From: Jeff Circle
Sent: Friday, March 06, 2009 12:26 PM
To: Antonios Zoulis; Fernando J Ferrante; James Vail; Jeffrey Mitman
Cc: Melanie Galloway; Mark Cunningham
Subject: FW: Oconee Flood Guidance
Attachments: EM 5.3 - Dam Failure.pdf

Attached is a copy of Engineering Manual E.M. 5.3, Beyond Design Basis Mitigation Strategies for Jocassee Dam Failure. This document provides instructions and guidance for the TSC to use to mitigate a catastrophic failure of the Jocassee Dam. It was developed and implemented to satisfy the commitment made in our September 26, 2008 letter to have such guidance in place by the end of February 2009.

**Section Title: E.M. 5.3 – Evaluations by Station Management In the TSC - Beyond Design
Basis Mitigation Strategies for External Flood Mitigation**

This document discusses the staff's review of Duke Energy's Oconee Nuclear Station procedure titled "Evaluation by Station Management in the TSC – Beyond Design Basis Mitigation Strategies for Jocassee Dam Failure," number EM 5.3, revision 0. The review includes two distinct parts: First, it looks at the mitigation strategy, hereafter called a procedure, and identifies problems and questions with that procedu

AP/47 Simplified I-flow Diagram for Oversight

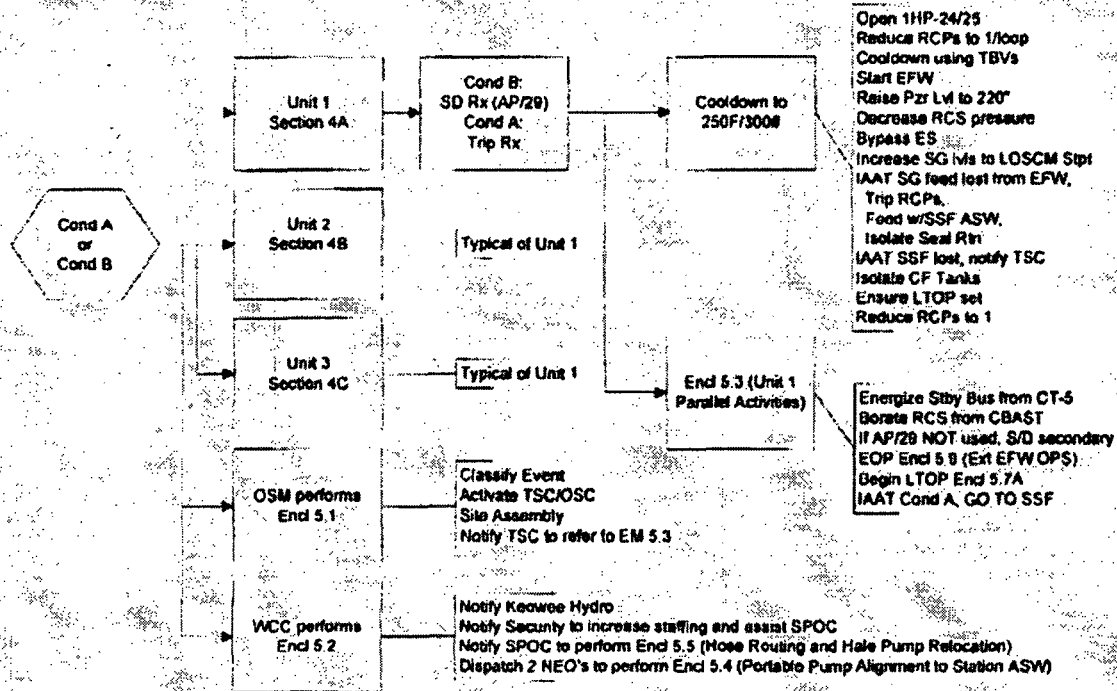
1,000,000 gal H₂O in [TP#] → How to verify?

AP/47 Simplified Flow Diagram for Oversight

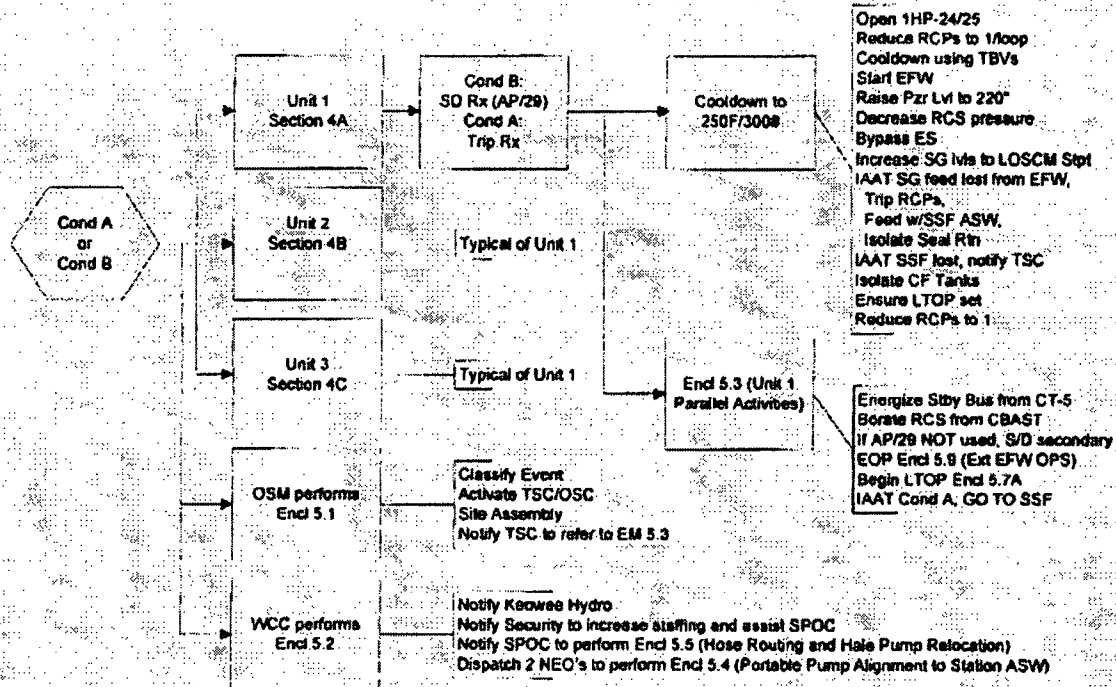
1,000,000 gal H₂O in CTP#1 → How to verify?
